**GUNNISON COPPER PROJECT
COCHISE COUNTY, ARIZONA
AQUIFER PROTECTION PERMIT APPLICATION
INVENTORY NO. 511633
RESPONSE TO COMMENTS**

APRIL 2017

FIGURE 2-5
INTERMEDIATE MONITORING WELL
LOCATIONS: YEAR 1

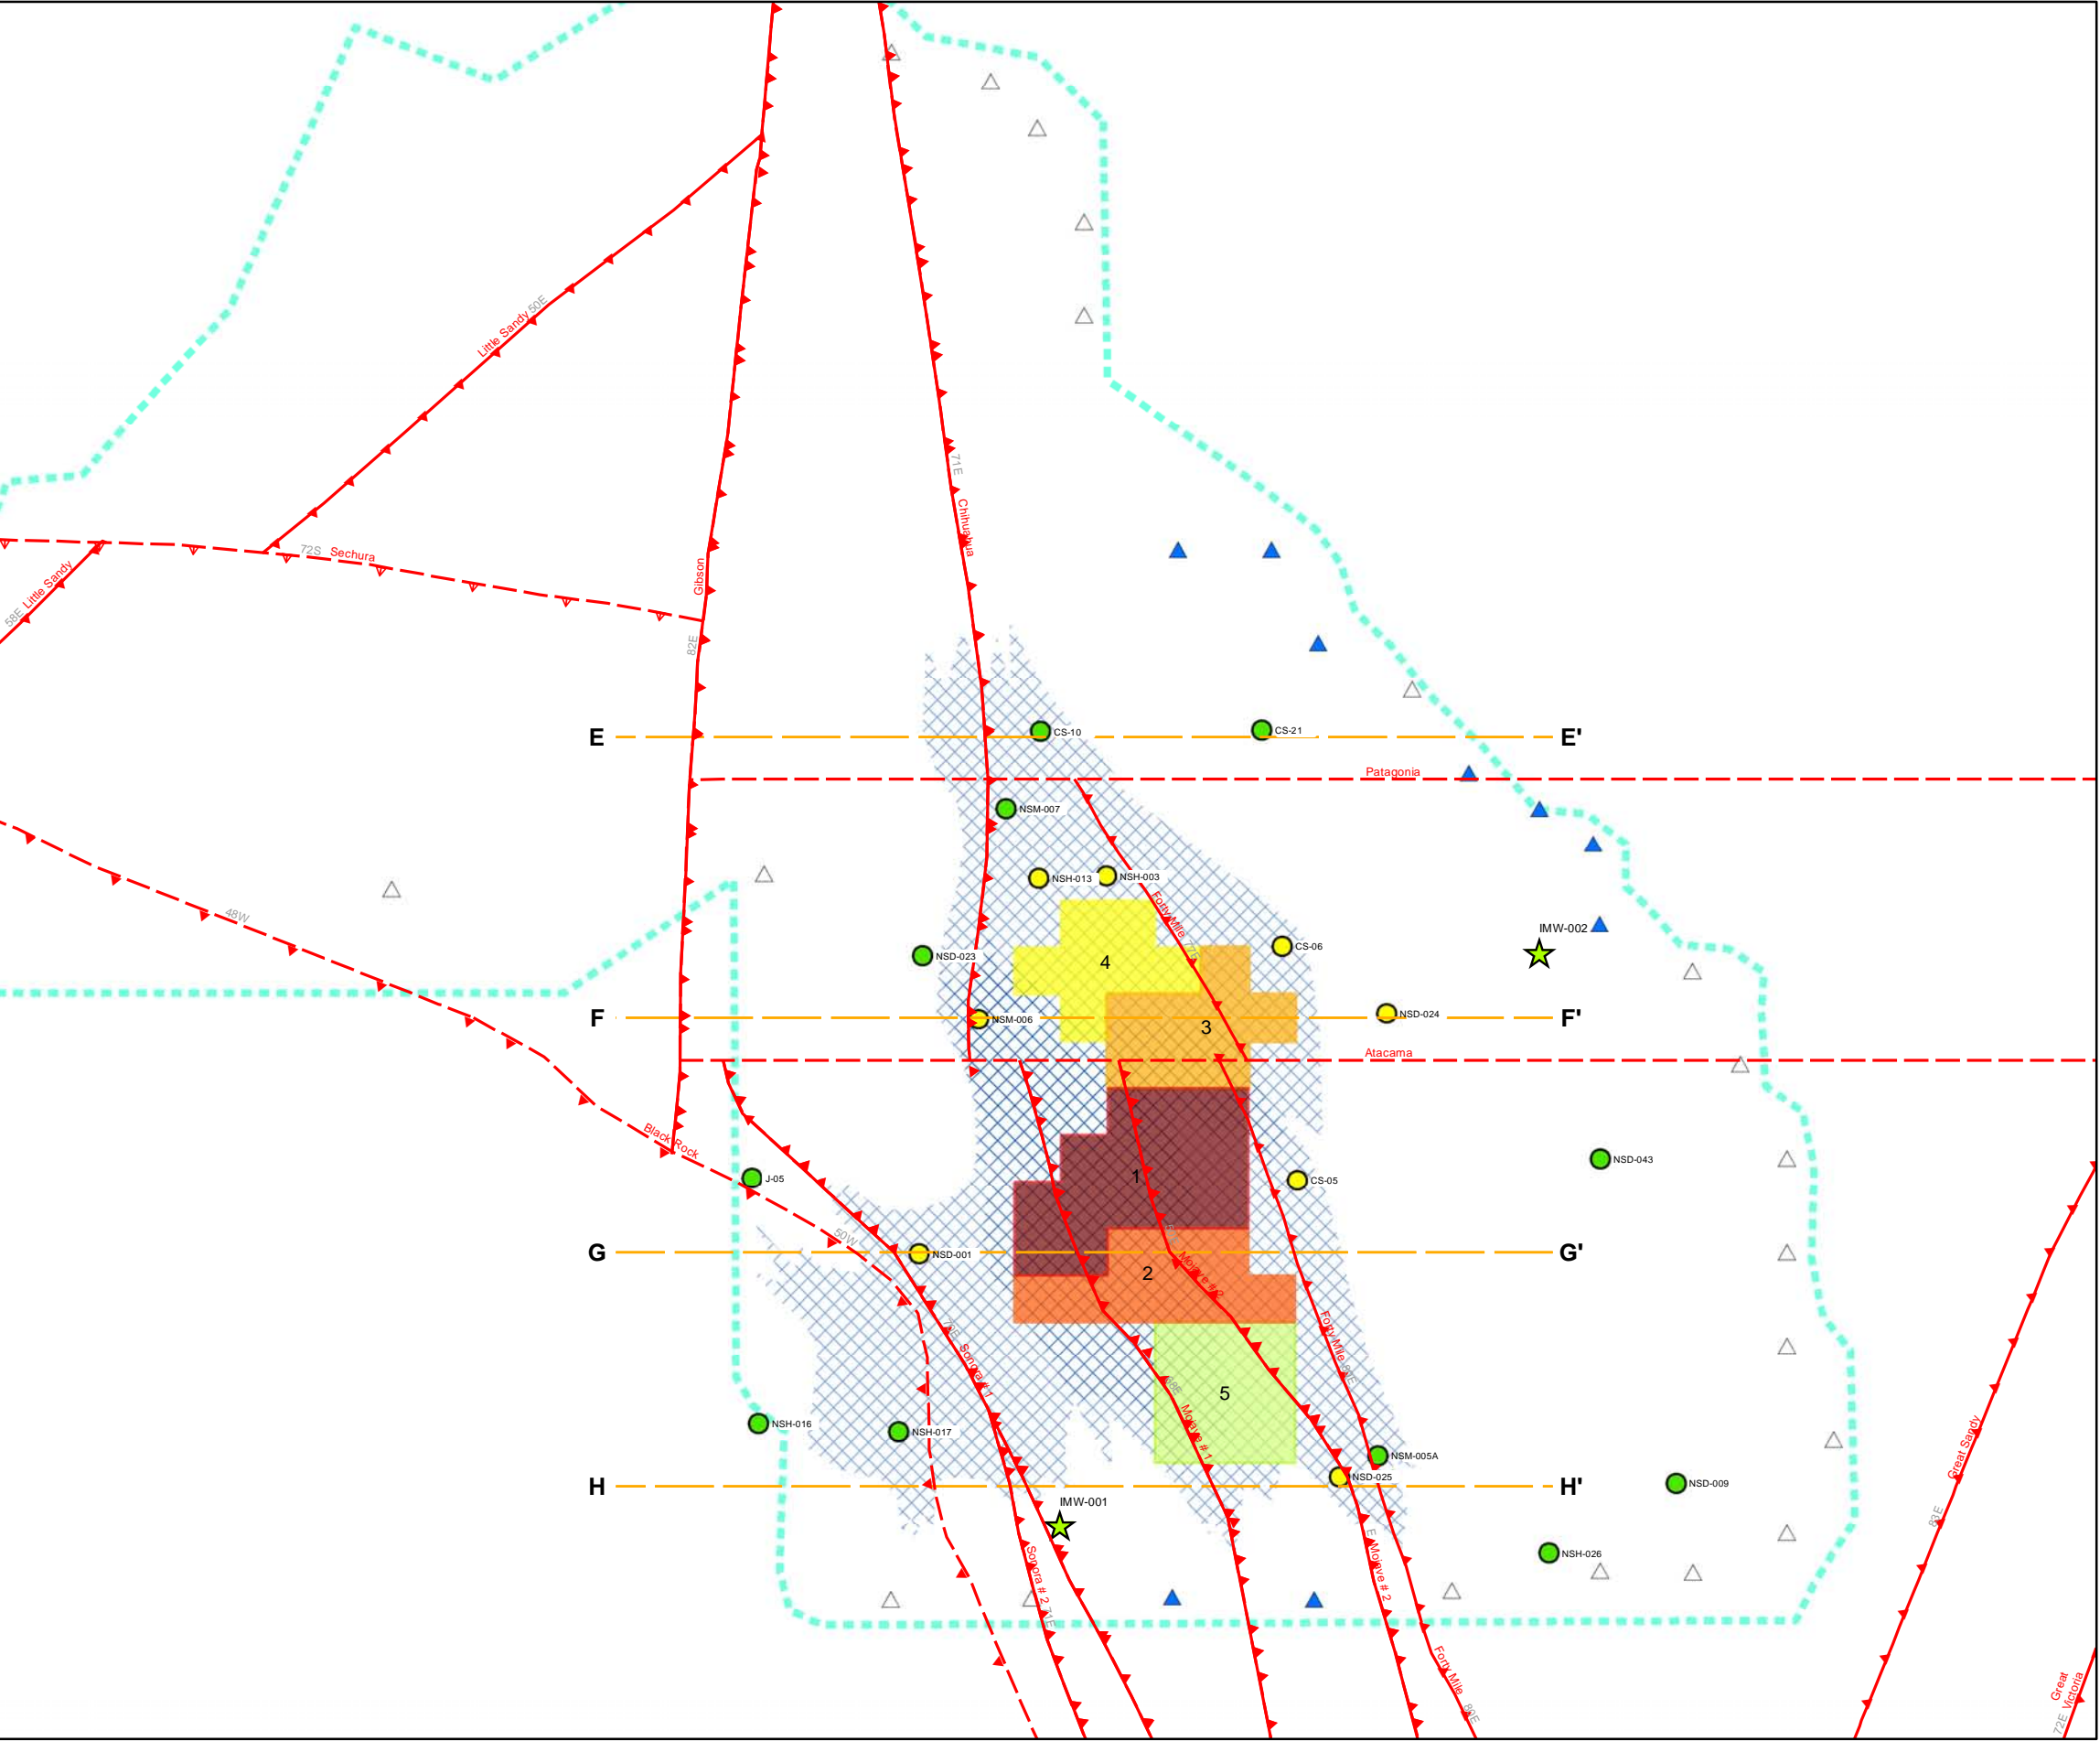
Excelsior plans to use the North Star Hydrology (NSH) wells as intermediate monitoring wells for the purposes of early detection. There appear to be gaps in NSH well coverage in the eastern portion of the site. Please provide a discussion on why intermediate wells are not needed in the eastern portion of the site per A.A.C. R18-9-A202(A)(5)(b).

- Include the mine blocks on the figure or figures to indicate how the NSH wells and other additionally proposed "intermediate wells" would relate to the various mine blocks.

- Indicate whether all NSH wells and other additionally proposed "intermediate wells" would be monitored during which or all phases of mining.
 - if they will not all be continuously monitored, when they will be monitored and provide their screen intervals.

IMW's will consist of existing core, observation or aquifer test wells, supplemented where considered necessary by additional wells to be drilled. Figures 2-5, 2-6, 2-7, and 2-8 show proposed IMW's for Year 1, Year 5, Year 10, and Year 13 respectively. Figure 2-9 shows cross sections through Stage 1 blocks, showing the IMW locations and the significant structures that they intersect. Given the spacing and location of existing holes available to be used as an IMW, two additional holes are proposed to extend coverage beyond existing locations. These holes (shown as stars on the above mentioned figures) will be drilled and installed as IMWs prior to

FIGURE 5

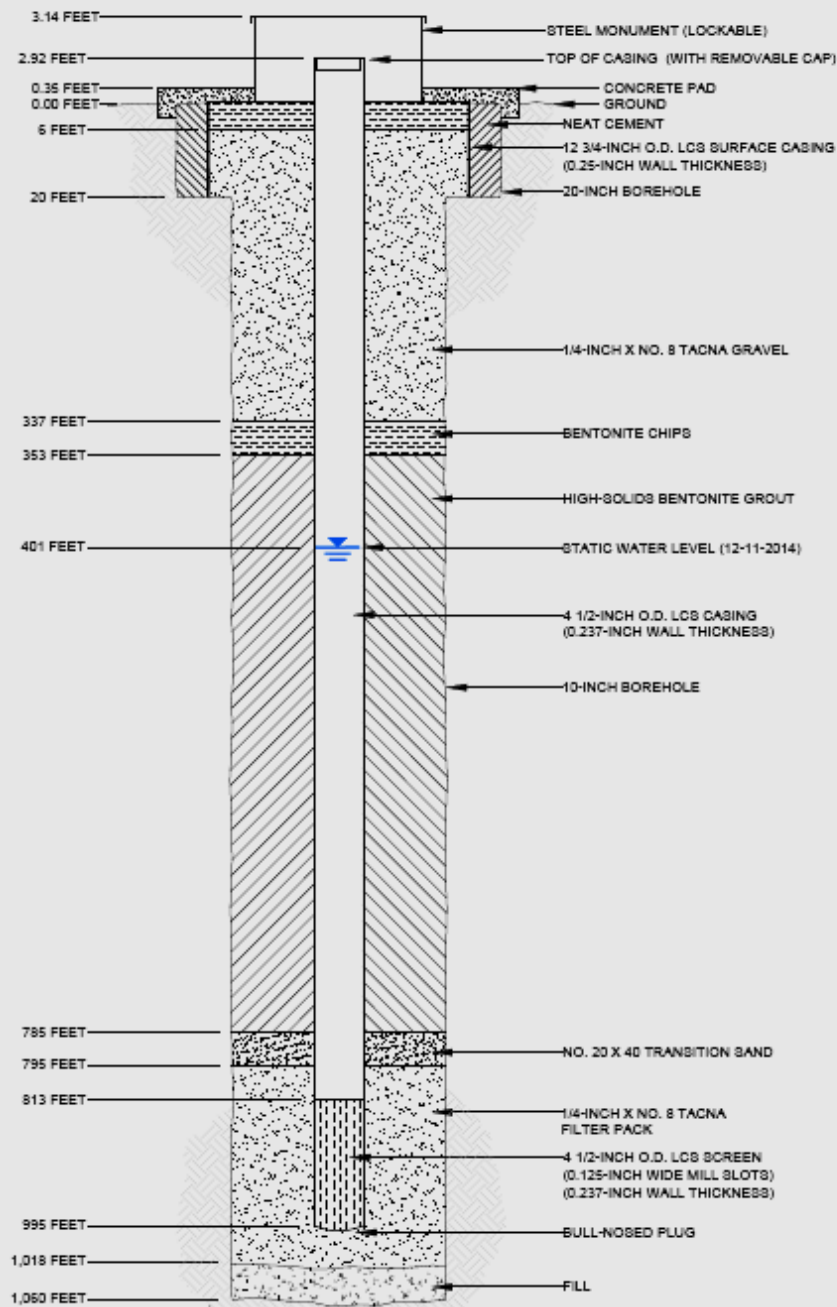
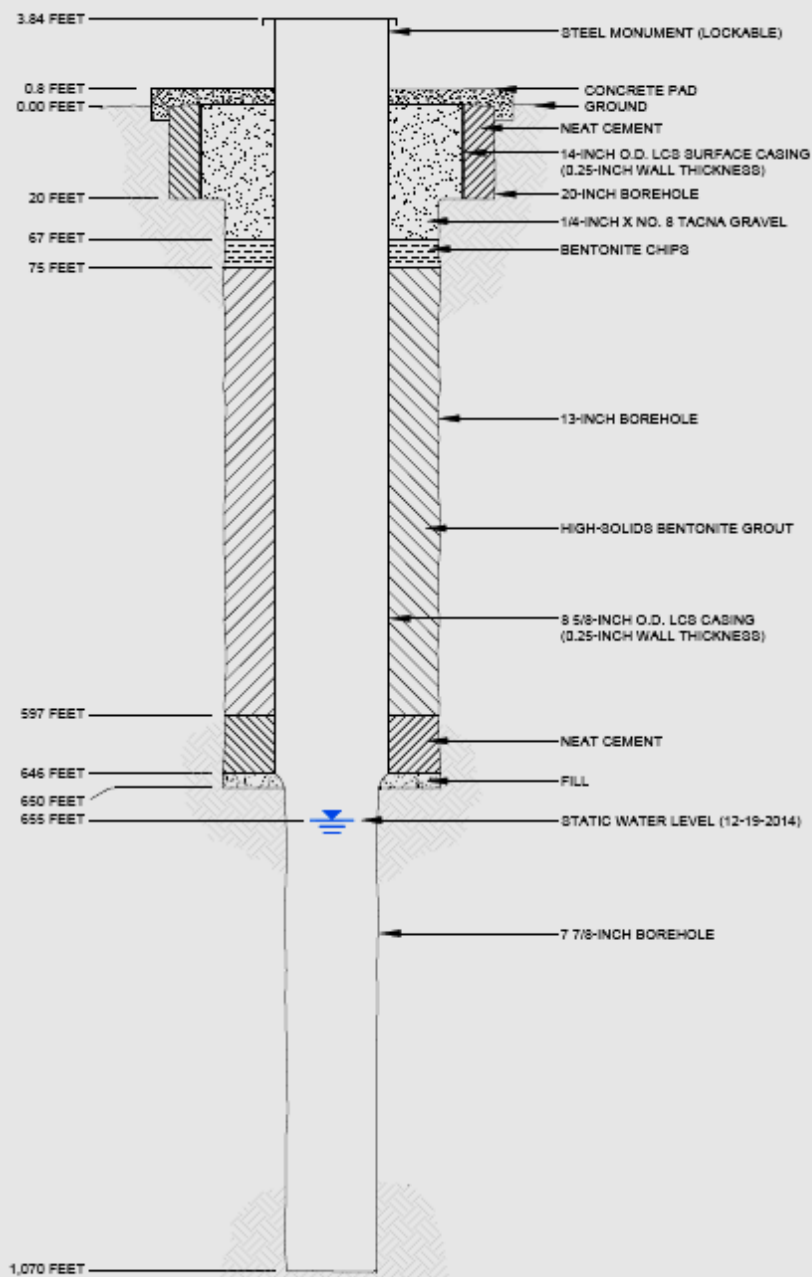
Excelsior must provide a brief description on whether NSH-13 and NSH-9 are constructed in a similar manner as CS-10 and CS-14.

Construction of NSH-9 and NSH-13 was documented in Appendix F of the APP Application. The as-built diagrams from Appendix F are provided below.

Except for NSH-13, these wells are unsuitable for monitoring for LNAPL, as their screen/open intervals are submerged. Presence of LNAPL in CS-10 and CS-14 is consistent with addition of petroleum to lubricate drill rods, as stated in our original response.

FIGURE 8-1
Updated Mining
Block Sequence

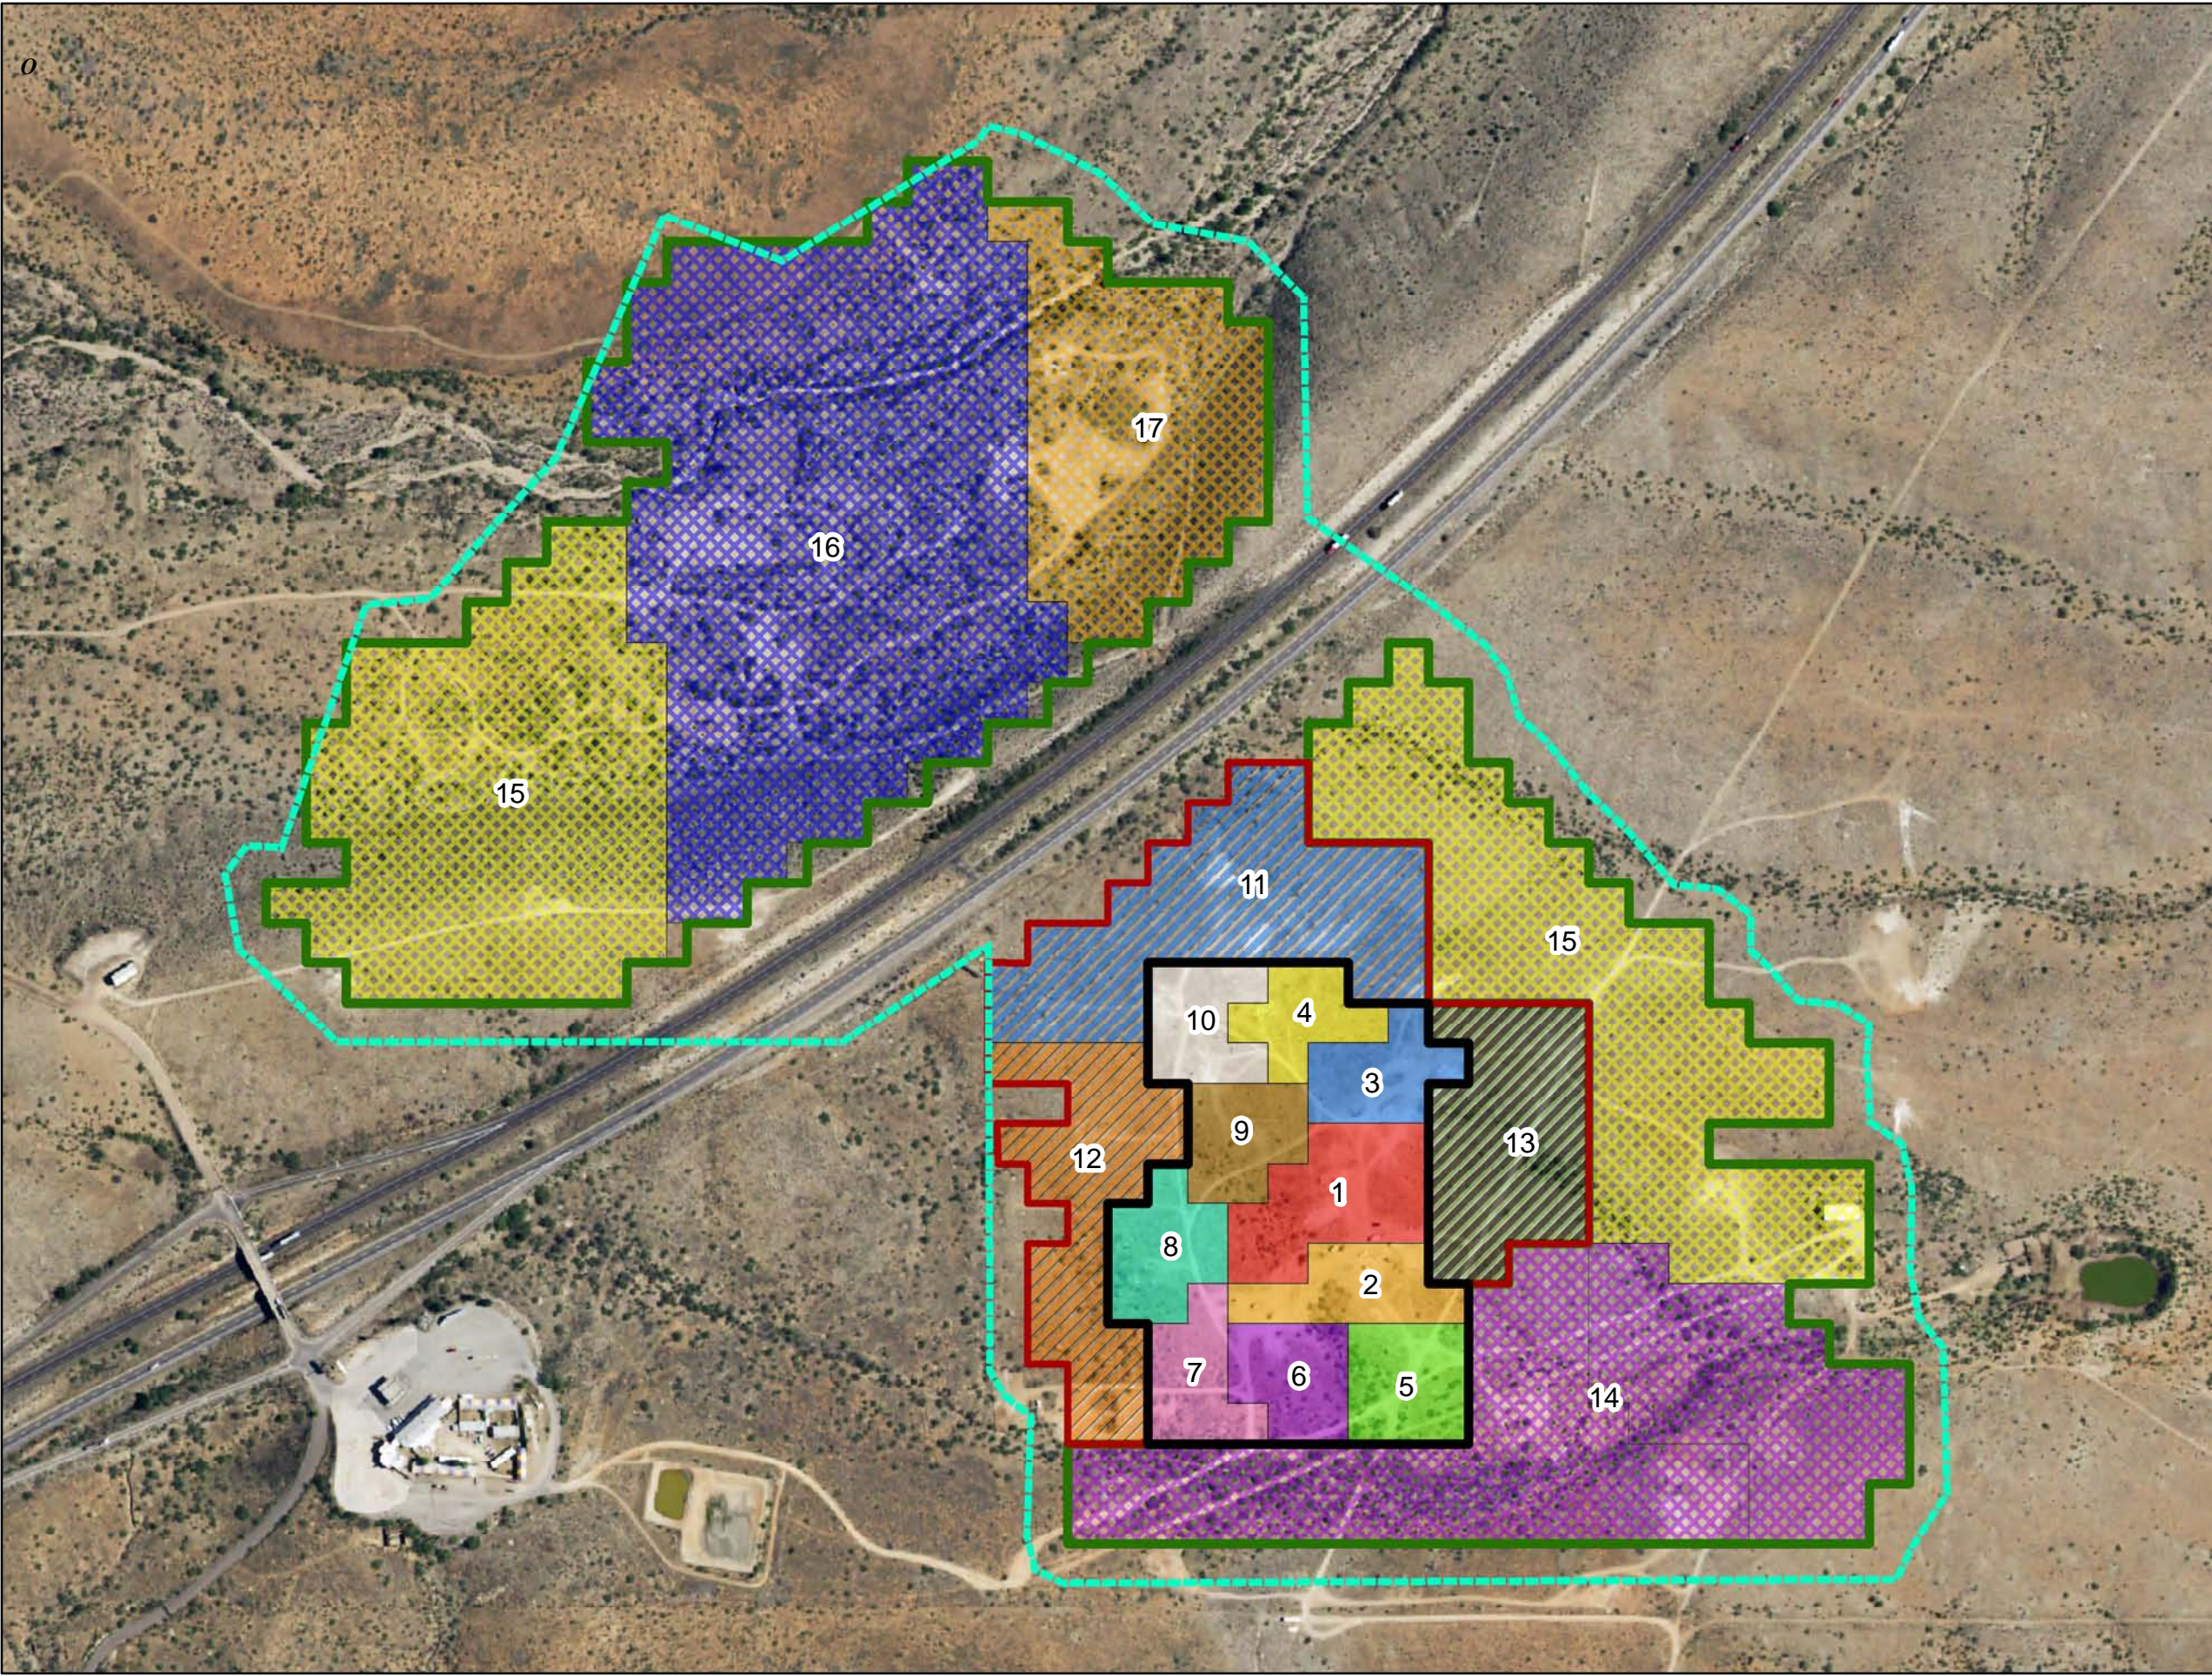
- i. Figure 8-1 Updated Mining Block Sequence provides a color scheme for each mine block over 17 years. Some of the colors are very close to each other and are difficult to differentiate. ADEQ requests that the colors be better differentiated between the mine blocks so the sequence is clearer by having different types of hatching and/or other distinguishing mark added to the colors to help clarify mining sequence.

Figure 8-1 has been revised as requested to more clearly differentiate the mining blocks by year of operations.
